Access Compliance Report

Public Rights-of-Way

(Curb Ramps)

Intersection ID: 10029688	Main Street: KINGSLEY_VIEW_DR	Cross Street: N/A	Location: SE
ADA ID: 9A61C6995065	Ramp Type: PerpDiag	Initial Pass/Fail: Fail	Overall Compliance: No
Codes/Mitigation Info/Possible Solution		Field Measurements/Component Compliance	
Severity Score: 25

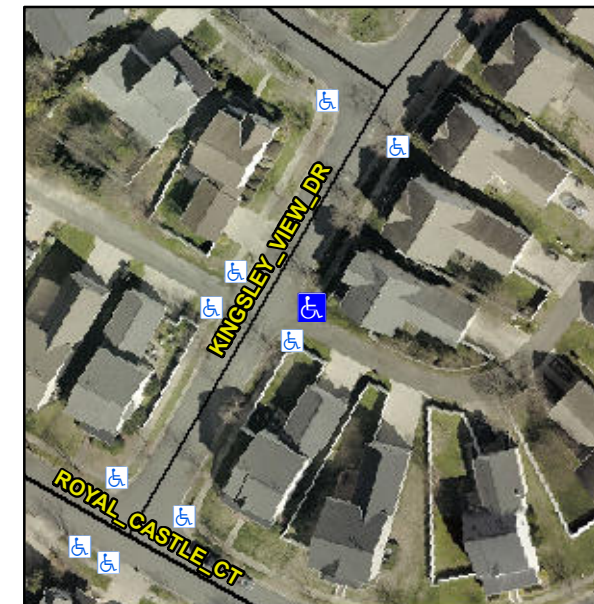
Compliance	Description	Data	Compliance	Description	Data
N/A	Ramp Length (in)	182.0	Yes	Ramp Slope (%)	12.2
Yes	Ramp Width (in)	48.0	Yes	Ramp XSlope (%)	0.4
N/A	Flare Type LT	N/A	N/A	Flare Type RT	N/A
N/A	Flare Slope LT (%)	N/A	N/A	Flare Slope RT (%)	N/A
N/A	Flare Traversable LT?	N/A	N/A	Flare Traversable RT?	N/A
N/A	Landing Length (in)	N/A	N/A	DWS Provided?	N/A
N/A	Landing Width (in)	N/A	N/A	DWS Contrast?	N/A
N/A	Landing Slope (%)	N/A	N/A	DWS Length (in)	N/A
N/A	Landing X Slope (%)	N/A	N/A	DWS Full Width?	N/A
N/A	Landing Curb? (Y/N)	N/A	N/A	DWS Offset (in)	N/A
N/A	Shared Landing?	N/A			
N/A	Gutter Ponding?	N/A	N/A	Gutter Slope (%)	N/A
N/A	Gutter Lip Ht (in)	N/A	N/A	Gutter X Slope (%)	N/A
N/A	Painted X Walk1?	No	N/A	Painted X Walk2?	No
	X Walk 1 Direction	To NW		X Walk 2 Direction	To SW
N/A	X Walk 1 Width (in)	N/A	N/A	X Walk 2 Width (in)	N/A
	X Walk 1 Slope (%)	3.1		X Walk 2 Slope (%)	7.8
	X Walk 1 X Slope (%)	3.5		X Walk 2 X Slope (%)	3.3

N/A	Ramp inside XWalk1?	N/A	N/A	Ramp inside XWalk2?	N/A
	Road Slope (%)	0.2	N/A	Clear Space?	N/A
	Road X Slope (%)	6.1	N/A	Clear Space to XWalk (in)	N/A
N/A	Any Obstructions?	N/A	N/A	Storm Grate/Utility Hazard?	N/A
	Obstruction Type			Storm Grate/Utility Type	
		N/A			N/A
			Yes	Surface Condition? (G/P)	Good

Remove & Replace Curb Ramp With Two New Directional Ramps or Equivalent.
